# Access Compliance Report

## Public Rights-of-Way

Intersection ID: 30475	Main Street: PLANTERS_ROW_DR	Cross Street: WALKING_STICK_DR	Location: SW
ADA ID: AD27A3DEE1A4	Ramp Type: PerpDiag	Initial Pass/Fail: Fail	Overall Compliance: No
Severity Score: 25			
Codes/Mitigation Info/Possible Solution		Field Measurements/Component Compliance

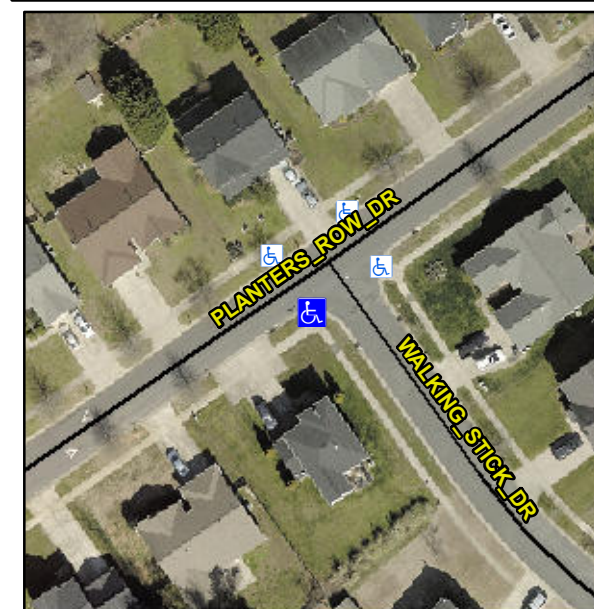
**Not Found, R304.5.3**

Compliance	Description	Data	Compliance	Description	Data
N/A	Ramp Length (in)	121.0	Yes	Ramp Slope (%)	8.2
Yes	Ramp Width (in)	48.0	No	Ramp XSlope (%)	12.5
N/A	Flare Type LT	N/A	N/A	Flare Type RT	N/A
N/A	Flare Slope LT (%)	N/A	N/A	Flare Slope RT (%)	N/A
N/A	Flare Traversable LT?	N/A	N/A	Flare Traversable RT?	N/A
N/A	Landing Length (in)	N/A	N/A	DWS Provided?	N/A
N/A	Landing Width (in)	N/A	N/A	DWS Contrast?	N/A
N/A	Landing Slope (%)	N/A	N/A	DWS Length (in)	N/A
N/A	Landing X Slope (%)	N/A	N/A	DWS Full Width?	N/A
N/A	Landing Curb? (Y/N)	N/A	N/A	DWS Offset (in)	N/A
N/A	Shared Landing?	N/A			
N/A	Gutter Ponding?	N/A	N/A	Gutter Slope (%)	N/A
N/A	Gutter Lip Ht (in)	N/A	N/A	Gutter X Slope (%)	N/A
N/A	Painted X Walk1?	No	N/A	Painted X Walk2?	No
	X Walk 1 Direction	To NE		X Walk 2 Direction	To NW
N/A	X Walk 1 Width (in)	N/A	N/A	X Walk 2 Width (in)	N/A
	X Walk 1 Slope (%)	3.6		X Walk 2 Slope (%)	1.8
	X Walk 1 X Slope (%)	2.2		X Walk 2 X Slope (%)	3.5

**Remove & Replace Curb Ramp With Two New Directional Ramps or Equivalent.**
